Re: Response to June 11, 2002 DEQ Comments,
Pre-Remedial Investigation, Brix Maritime Site, ECSI No. 2364

The purpose of this letter is to provide written response to the above referenced comments by DEQ on the May 22, 2002 Pre-RI Assessment Work Plan prepared by Anchor Environmental, L.L.C. (Anchor) on behalf of Brix Maritime Company (Brix). Resolution of the issues addressed in the June 11, 2002 DEQ letter has resulted from various telephone conversations with DEQ, from a meeting on June 19, 2002 with DEQ, and from a revised monitoring well location map sent electronically to DEQ on June 27, 2002.

Figure 1
Site Map - Brix Maritime

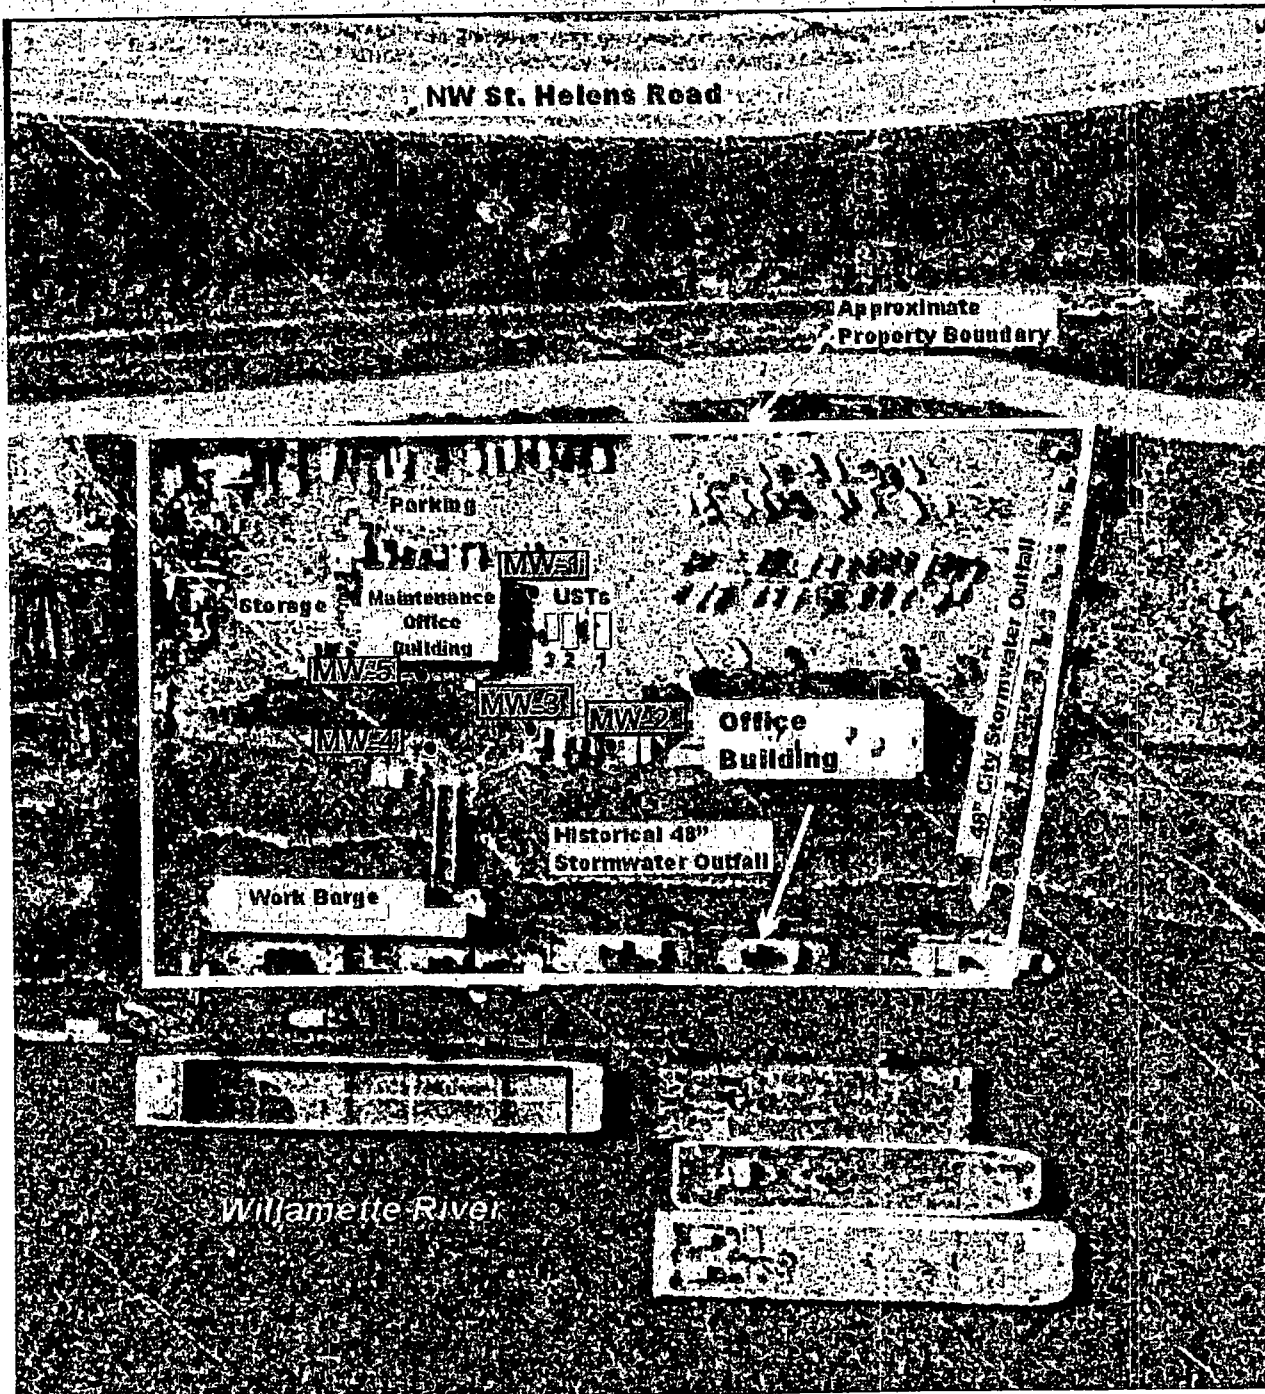
2. Page 5. Section 5.1.1. DEQ believes additional groundwater monitoring wells should be installed and the location of the proposed wells should be modified. DEQ recommends that we meet, as soon as possible, to agree upon potential well locations. It is DEQ's expectation that wells will be installed in the following areas:

- At least one well should be installed in potential source areas (i.e., near B-21, B-27/B-28);
- Approximate location where historic drainages discharged to the river (see 1961 aerial photograph); and
- Other silt low areas, where preferential groundwater discharge pathways may occur.

3. A revised site plan should be prepared that is accurate and to scale. The scale/distances on the current maps do not appear to be consistent with the aerial photographs for the site. Please provide an overlay of the site onto the 1961 aerial photograph to locate additional wells.

Based on a review of site historic aerial photos, the location of pre-fill topographic drainage ways was evaluated to finalize the location of monitoring wells. On June 27, 2002, Anchor provided DEQ with a 1991 aerial photograph of the site with the 1961 pre-fill drainage swales marked on the photograph. The attached map (Figure 1) presents the location of the four proposed monitoring well locations. This map reflects a new location of MW-2 (5 to 10 feet southeast of former boring B-15) to place the well in the potential topographic low in the silt unit, and the addition of a fifth monitoring well to be placed approximately 15 feet map north of B-18. The intent of this additional well is to address DEQ's concerns regarding potential sources to borings B-17 and B-18, and to provide additional groundwater elevation data.

The attached map, Figure 1, with proposed monitoring well locations, is constructed on an aerial photo base dated 1991. The well locations were also evaluated using a 1961 site aerial photo with the photo scale adjusted to match the 1998 photo scale as closely as possible, as described in the response to DEQ comment 2.
